ALERT SERVICE BULLETIN

505-21-26

MODEL AFFECTED: 505

SUBJECT: FUEL CELL VENT PREFLIGHT INSPECTION,

Figure 1 – Fuselage – Front

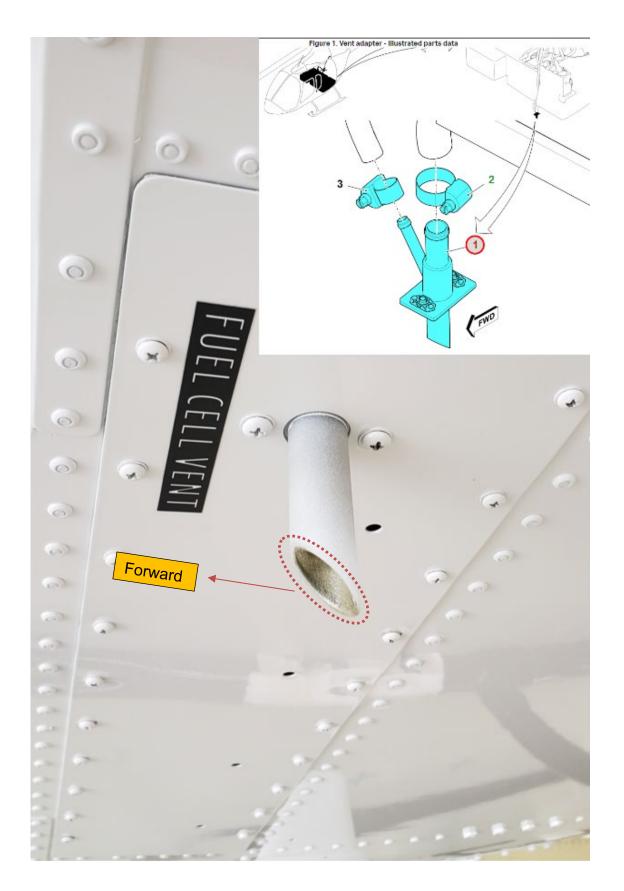
- 1. Prepare the helicopter for maintenance.
- 2. Inspect the fuel vent tube for damage and ensure the bevel (scarf) is facing forward (Figure 1). The tube should have smooth edges and be free of chips or cracks.
- 3. Insert applicable BHT-505-FM-1 Rev. 8 or BHT-505-FM-2 Rev. 2 Rotorcraft Flight Manual Revision.
- 4. Communicate to the Model 505 pilots and maintenance personnel the contents of the newly inserted Rotorcraft Flight Manual Revision change.
 - (1) Review paragraph 2-3-B-8, Fuselage Front, Item 10, Vents and Drains Condition and Security.
 - (2) Familiarize crew with fuel cell vent criteria for shape and opening facing forward (Figure 1).
 - (a) The Manufacturer's Data BHT-505-MD-1 and BHT-505-MD-2, Section 1, paragraph 1-24-C offers the following description.

Both the forward and aft vent lines are joined into a single vent line which exits at the bottom of the fuselage on the left side of the control tunnel. A scarf cut on the outlet of the vent line is oriented forward to slightly pressurize the fuel vent system while in forward flight.
